HARTZELL PROPELLER INC.
ALERT SERVICE BULLETIN
TRANSMITTAL SHEET
HC-ASB-61-313
Propeller - Counterweight Slug Bolt Inspection

July 15, 2009

This page transmits a revision to Alert Service Bulletin HC-ASB-61-313.

This revision is issued to change the following in the Alert Service Bulletin:

Counterweight Slug Attachment Bolt Identification
Figure 1

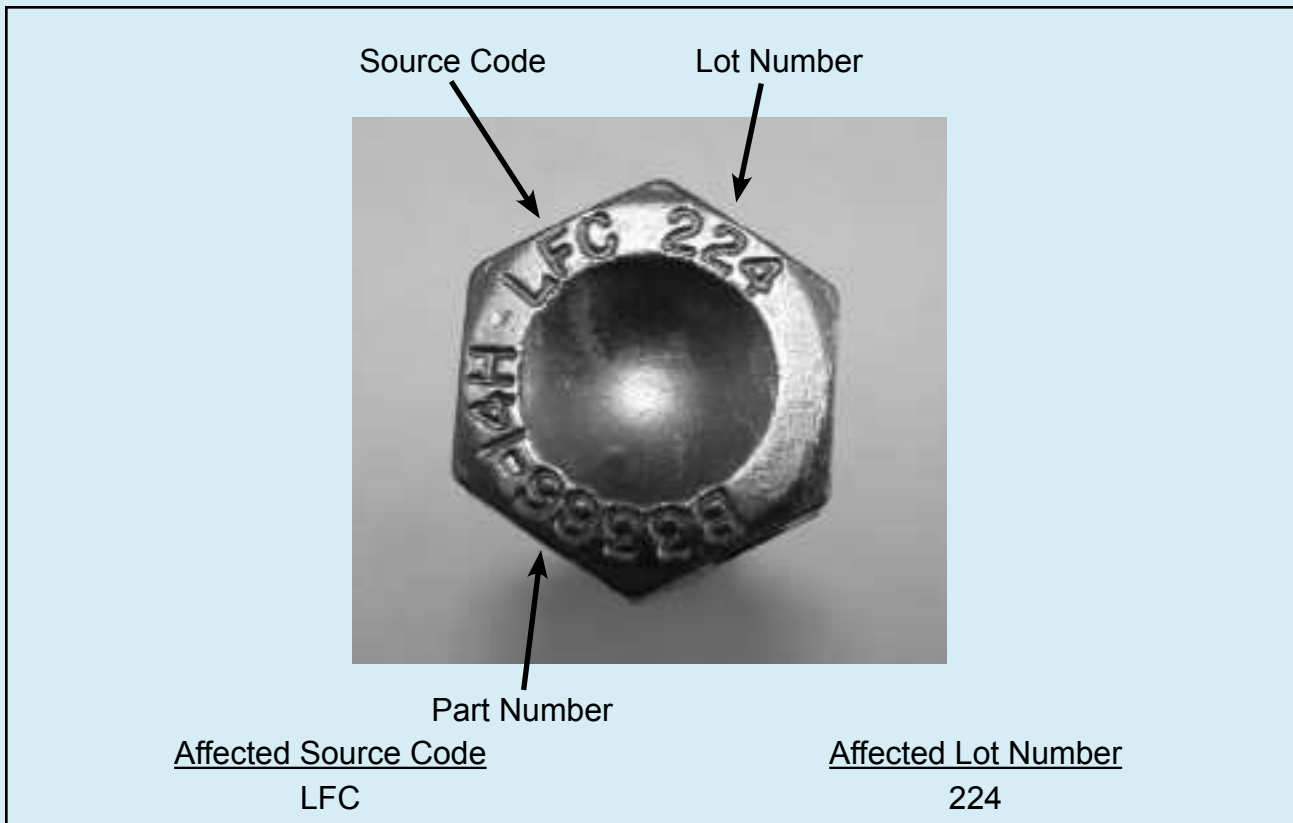
- (a) Locate the counterweight slug attachment bolts. Refer to Figure 2.
- (b) Inspect each B-3386-14H counterweight slug attachment bolt on the propeller for the affected LFC manufacturing lot. Refer to Figure 1.
 - 1 Bolts marked from another source code or lot number other than 224 are not affected by this Alert Service Bulletin.
 - 2 If only one counterweight slug attachment bolt on a counterweight slug is from the affected LFC manufacturing lot 224, both bolts may require replacement.
 - 3 Visually inspect all LFC manufacturing lot 224 counterweight slug attachment bolts for the following obvious signs of failure:

- (1) Inspect each B-3386-14H counterweight slug attachment bolt for the affected LFC manufacturing lot number. See Figure 1.
 - (a) Bolts marked from another source code or lot number other than 224 are not affected by this Alert Service Bulletin.
- (2) Immediately quarantine all affected bolts.
